Crystal River Nuclear Plant  
Docket No. 50-302  
Operating License No. DPR-72

Subject: Crystal River Unit 3 – Response to Request for Additional Information for the Review of the Crystal River Unit 3 Nuclear Generating Plant, License Renewal Application (TAC NO. ME0278) – Environmental Review

Re: Progress Energy Florida, Inc. –Crystal River Units 1, 2, & 3  
DEP File No. FL0000159-013-IW1S/NR  
Request for Additional Information (RFI) No. 1  
NPDES Permit Renewal Application

# **CR-3 Circulating Water Pump Flow Measurement Study**

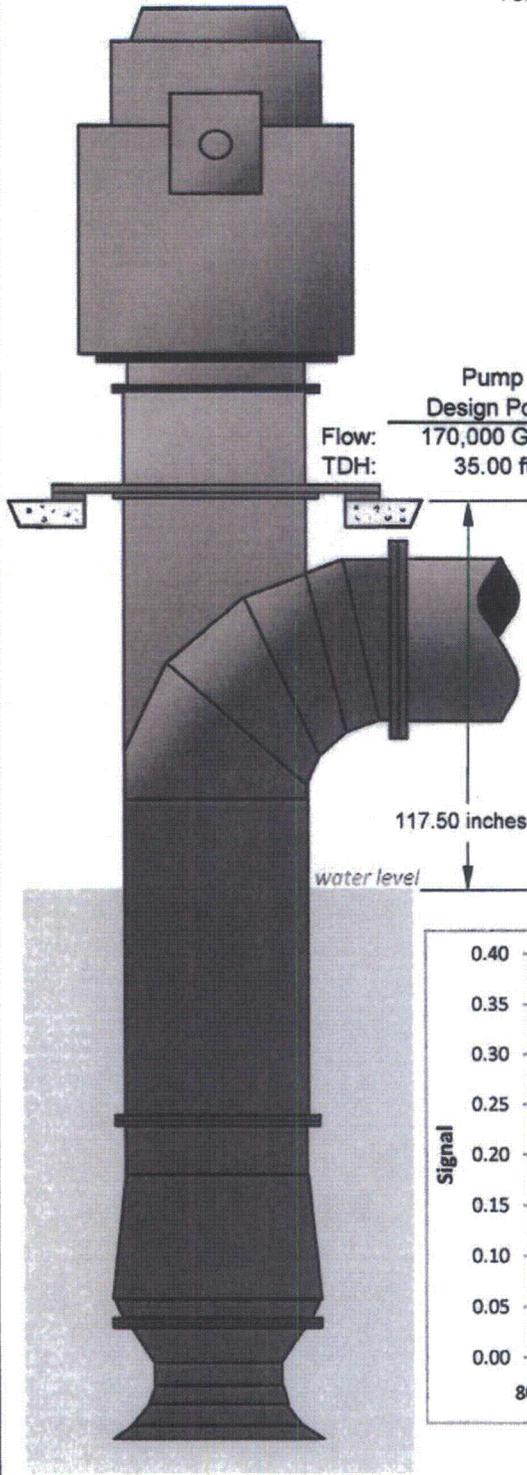
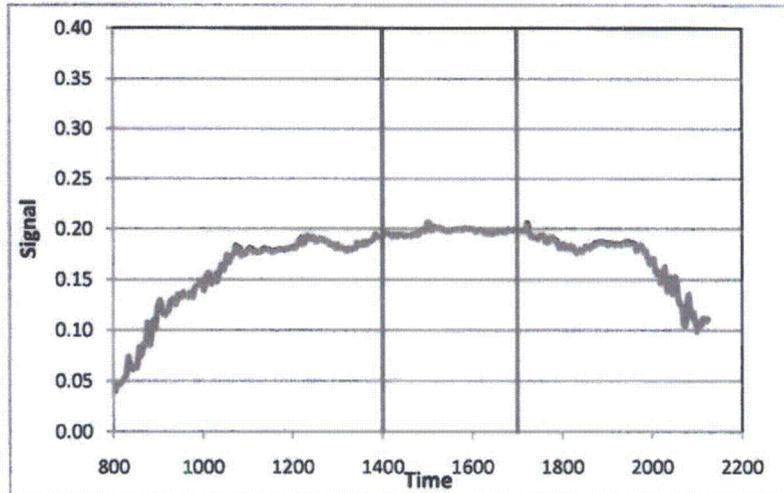
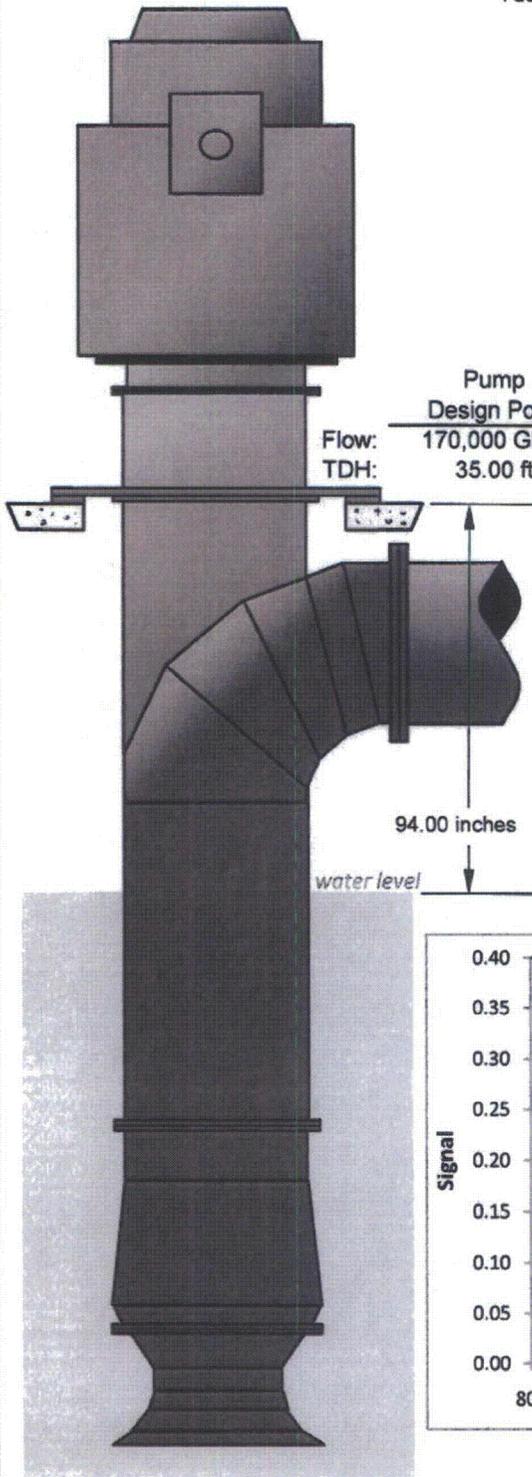
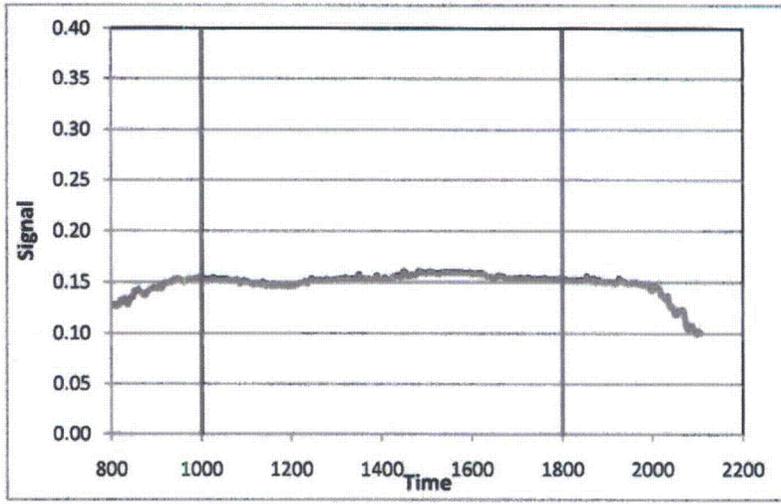
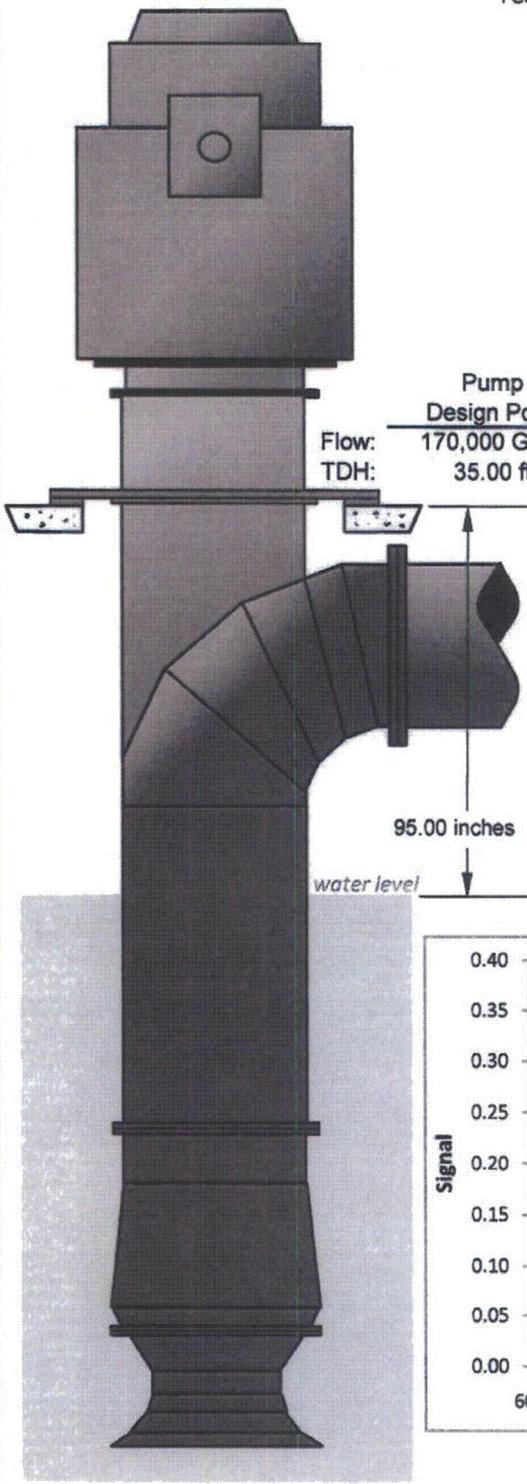
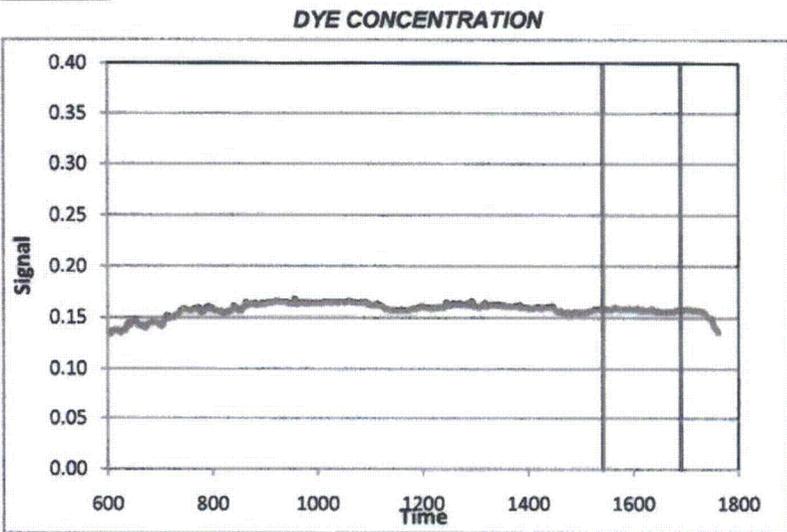
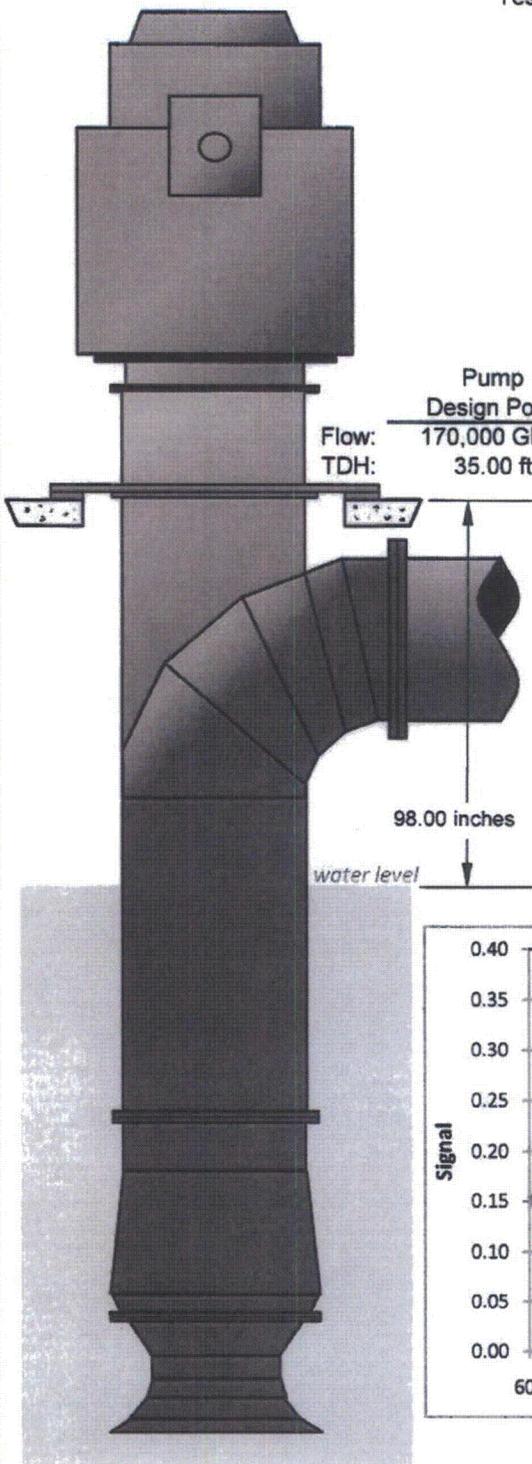
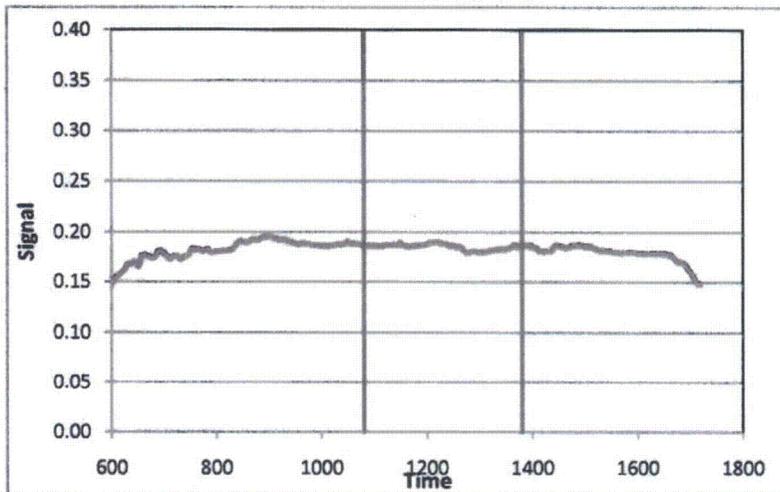
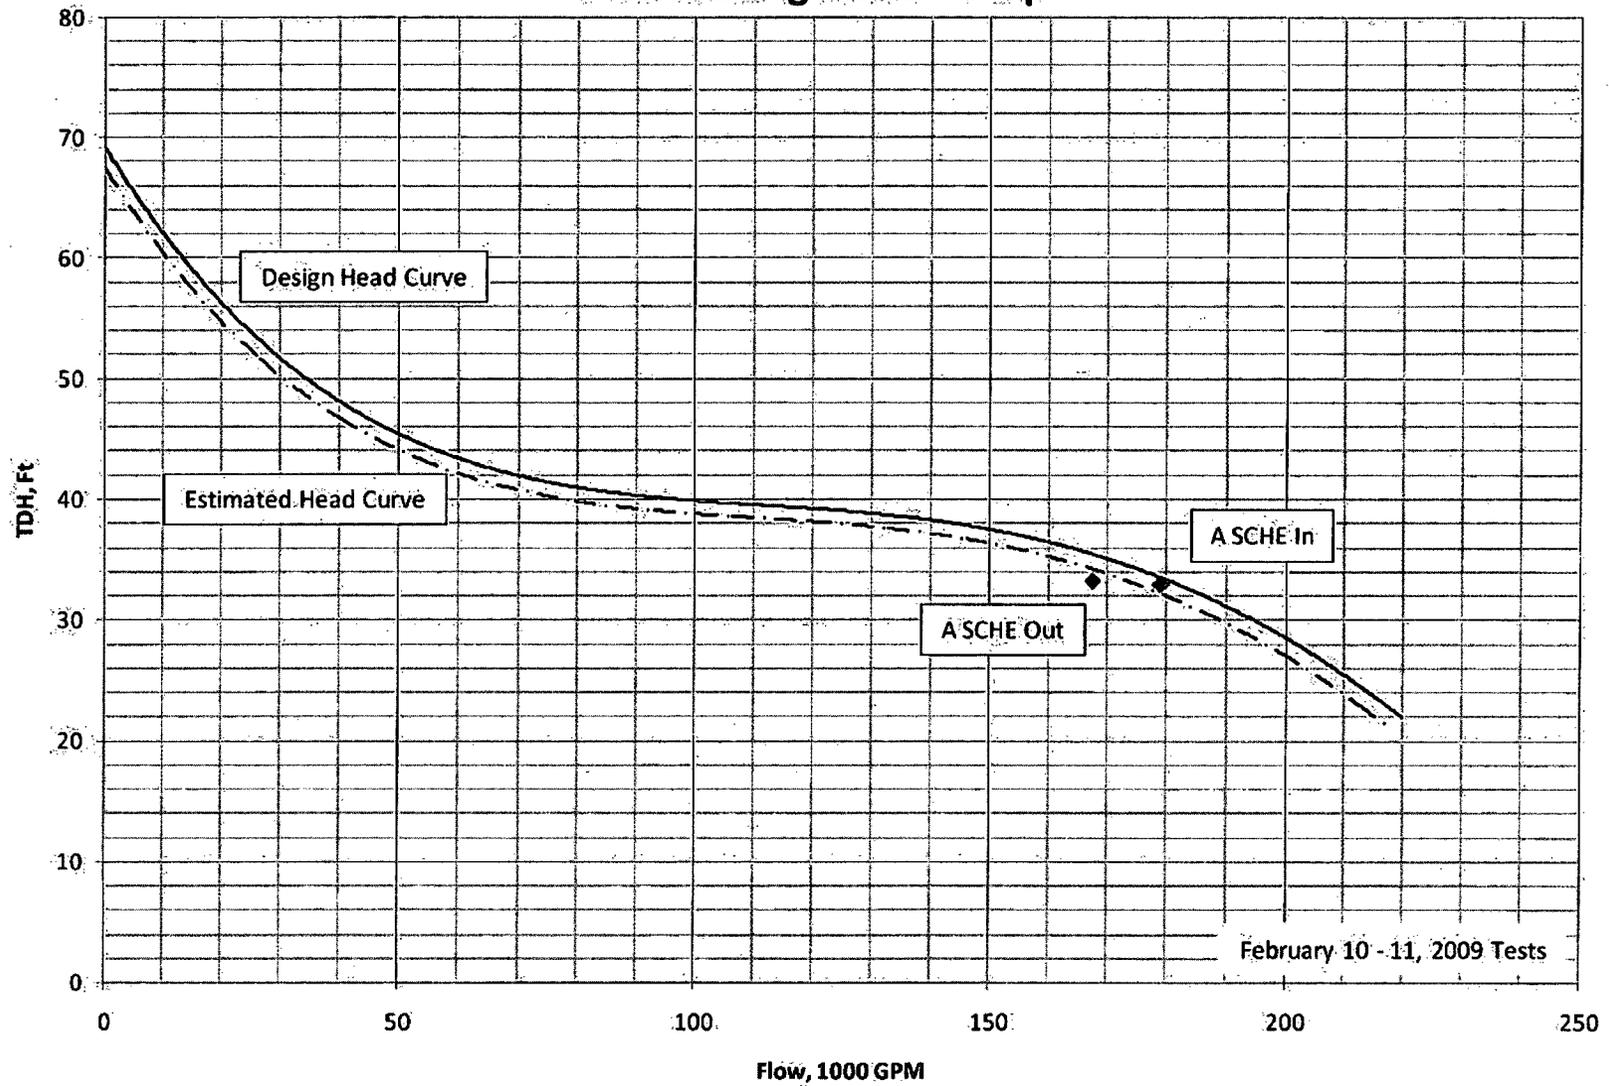
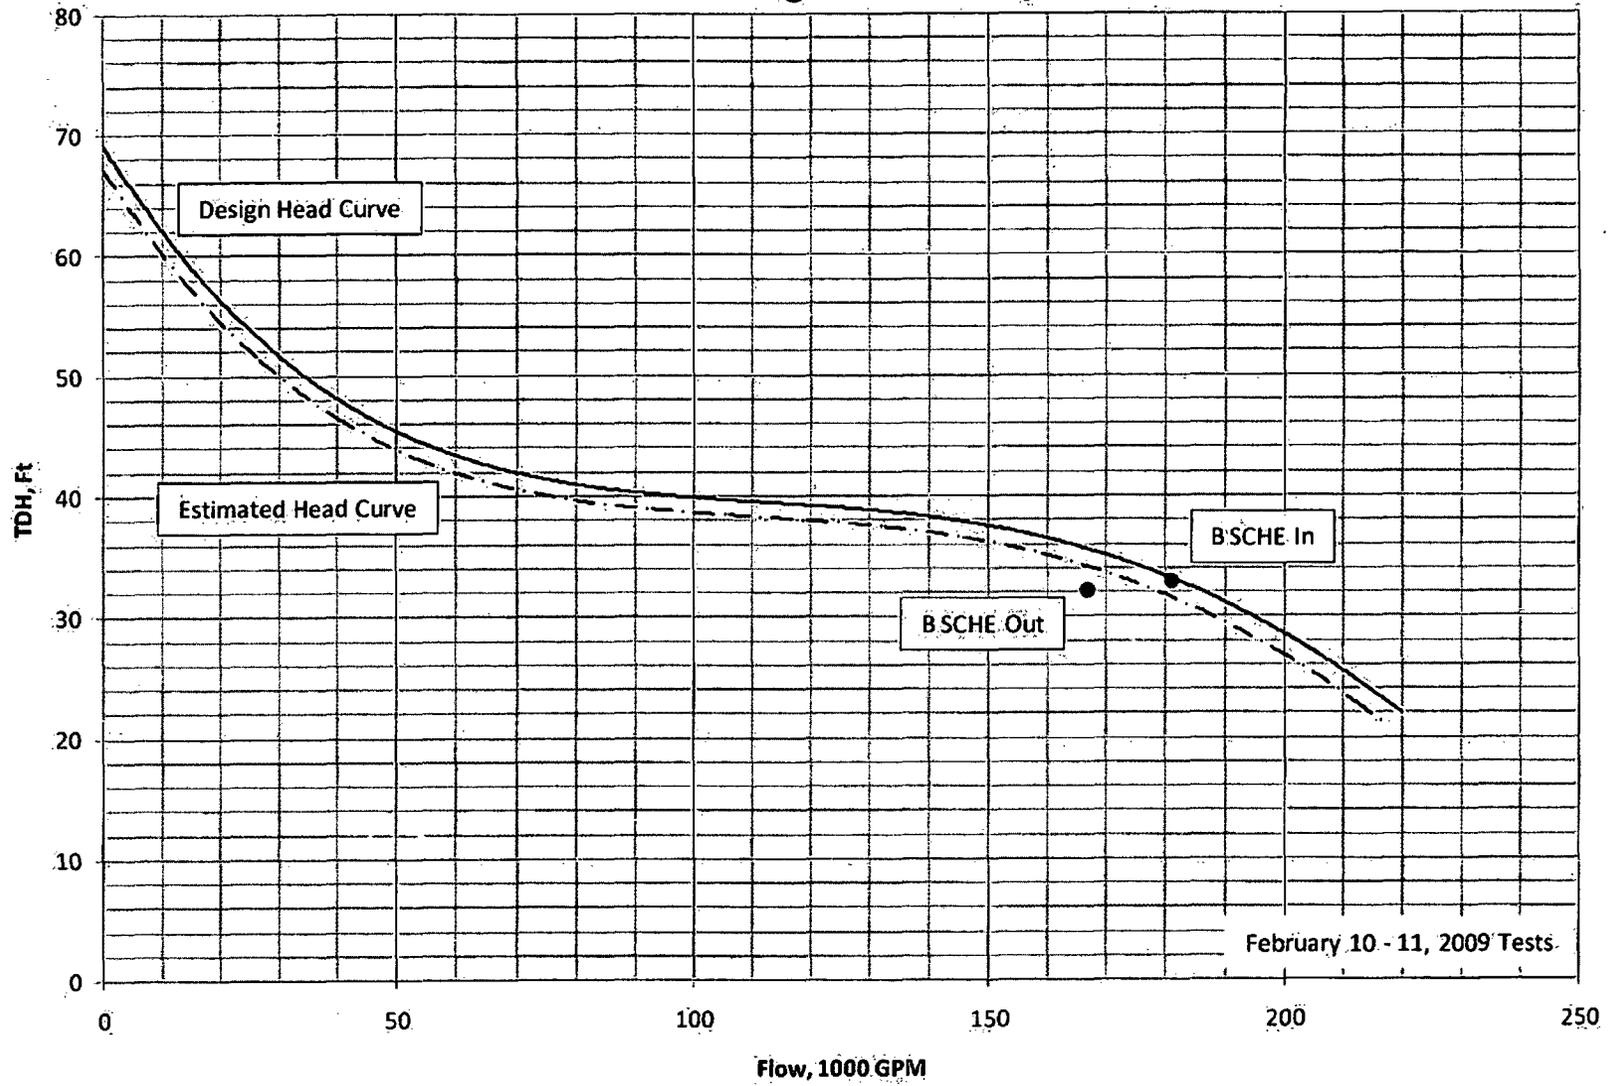
- 2. The information in Section VII, Part A, of Form 2CS, shows values that exceed existing permit limits for the combined cooling water flow of once-through cooling water from Units 1, 2, and 3 (Outfalls D-011, D-012, D-013 and D-00F). The maximum daily flow is limited to 1897.9 MGD for May 1<sup>st</sup> through October 31<sup>st</sup> and 1613.2 MGD during the remainder of the year. Please provide the following:**
  - a. Clarification whether the maximum combined flow of the cooling water intake structures actually exceeds permitted flows;**

Attachment 2 contains results from a dye test of the CR-3 circulating water pumps conducted during February 2009. All four circulating water pumps tested at various RPM and TDH levels averaged 160,843 gpm each. Corrected to 252 RPM, these pumps averaged 169,094 gpm, which is very close to the design point of 170,000 gpm per pump. The primary purpose of the test was to assist the plant in determining the impact of having a certain heat exchanger in service, however, pressure taps on the "A" and "B" pumps also allowed data to be taken and compared to design curves, copies of which are attached.

## Attachment 3

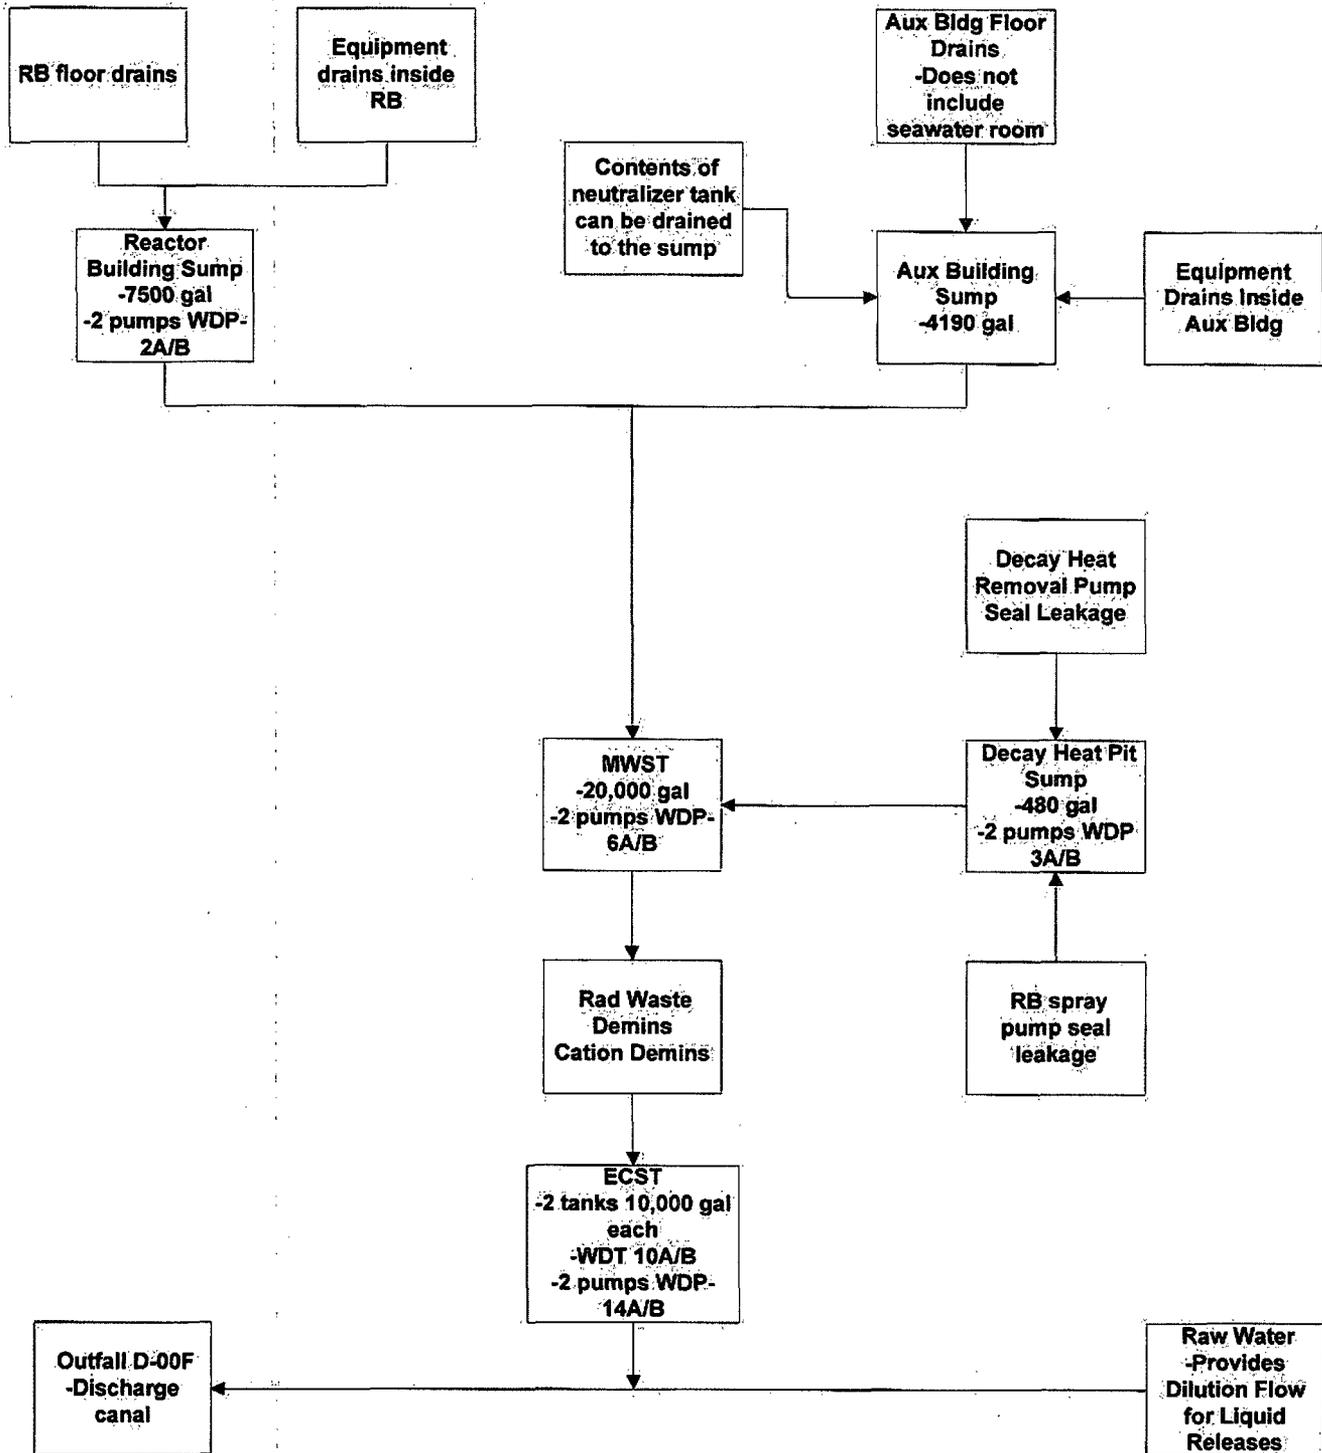
3. **Please provide a process description for the block identified as "MWST" on the Nuclear Services and Decay Heat Non-Contact Cooling Water system shown on the flow diagram in Attachment 3.**

- 7. The description for Outfall D-0C1 indicates that the wastewater discharge from the FGD blowdown treatment pond system is directed to the industrial wastewater percolation pond system. However, the flow diagram in Attachment 3 does not show this interconnection. Please provide the following:**
- a. an updated flow diagram
  - b. signed and sealed drawings of the FGD blowdown/stormwater pond system;
- and

Since the NPDES outfall associated with the IWW percolation ponds is only meant as an emergency outfall, specific inputs to the IWW percolation ponds were not listed on the drawing. Rather, these descriptions are all found in IWW permit no. FLA016960 (copy provided in Attachment 4). Nevertheless, we have revised the drawing to show the treated FDG blowdown to the IWW pond system (see Attachment 5). As far as signed and sealed drawings of the FGD blowdown ponds, this information was submitted to the Southwest District, via the siting office, on June 22, 2009.

Please see response to RAI comment no. 3. The MWST (miscellaneous waste storage tank) is part of the ECST system. Basically, the ECST receives processed low-volume wastestreams from the reactor building (i.e. floor and equipment drains) as well as auxiliary building sumps and drains. These wastewaters are collected in the MWST from which they are sent to the radwaste treatment system, which is a filtration, cation bed, ion exchange resin and purification system. From this treatment system, treated wastewater is collected in the ECST's. Discharges from the ECST's must be sampled, analyzed, and processed through radiological monitors to comply with NRC regulatory requirements pertaining to isotopic releases.
